STAFF RECOMMENDATION
1709 Beechwood Avenue
March 18, 2015

Application: New construction - addition
District: Belmont-Hillsboro Neighborhood Conservation Zoning Overlay
Council District: 18
Map and Parcel Number: 10416027000
Applicant: Michael Ward, Architect
Project Lead: Sean Alexander, sean.alexander@nashville.gov

Drawings:
Elevations

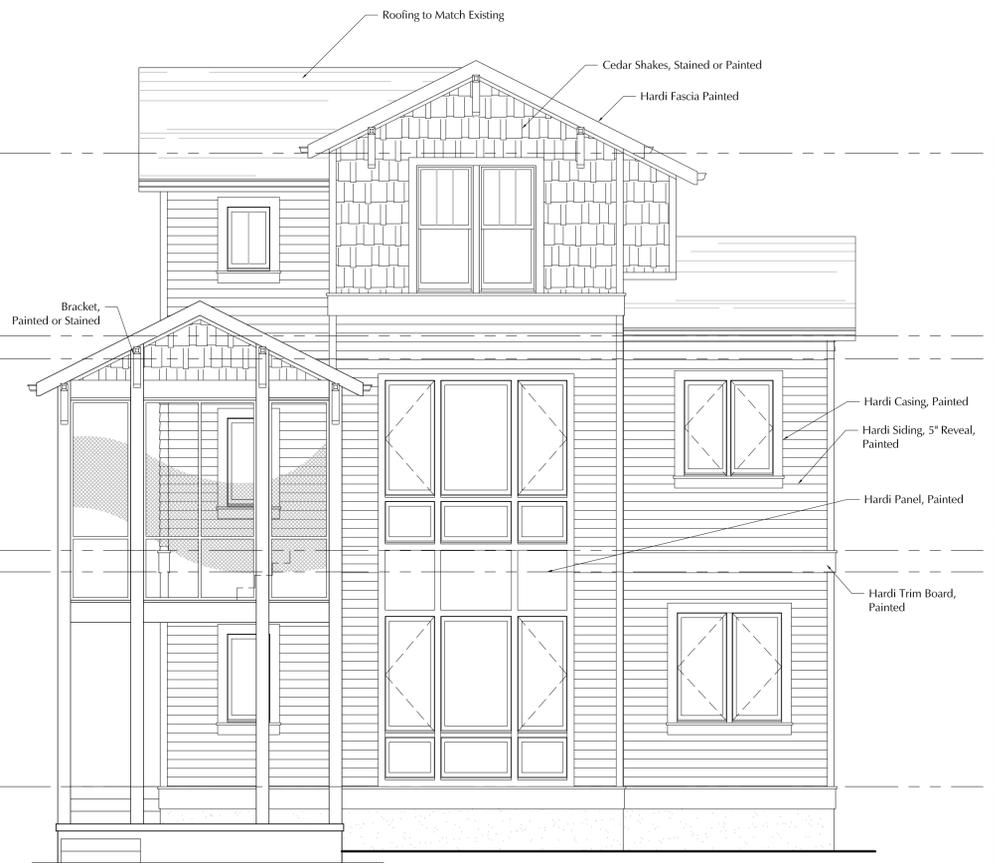
Height & Scale: The addition will be at the rear of the historic house, with a portion of the walls set in to differentiate it from the historic structure. The left side the alcove will be inset one foot (1') and extend back three feet (3'), the right will be inset two feet (2') and extend back four feet (4'). Beginning seven feet (7') back from the rear of the house on the right side there will be an open deck, and then a covered screened porch beginning nine feet (9') further back. The deck and porch will step five feet (5') out to the right side of the house, and the eave of the screened porch will be three feet (3') lower than the primary eave of the house.

The addition will tie into the rear wall of house twelve feet (12') behind the existing roof ridge and rise to be thirteen inches (13") taller at the rear. This taller portion will be behind the historic structure, beginning forty feet (40') back from the front of the house.

The Belmont-Hillsboro design guidelines suggest that additions should not be both taller and wider than an historic house unless doing so is necessitated by unusual constraints on the lot, such as an extreme grade change or an atypical lot parcel shape or size. The lot at 1709 Beechwood Avenue is fairly typical in its shape and size, and although the grade does change it drops to the rear to allow an additional story to be gained in the basement. For these reasons, Staff does not recommend approval of the addition being both taller and wider than the historic house.

Proportion and Rhythm of Openings: The majority of windows on the proposed addition are all twice as tall as they are wide, consistent with the historic proportions of openings. There would be shorter windows on the left side, but these are minimal and at the rear of the structure and will not have a significant impact on the character of the house. There are no large expanses of wall space without a window or door opening. With a condition that the first story windows on the right side of the house not be altered, Staff finds the project's proportion and rhythm of openings to meet Section II.B.1.g.

- The addition shall not be both taller and wider than the historic house; and
- The number and dimensions of the first story windows on the right side of the house not be altered.
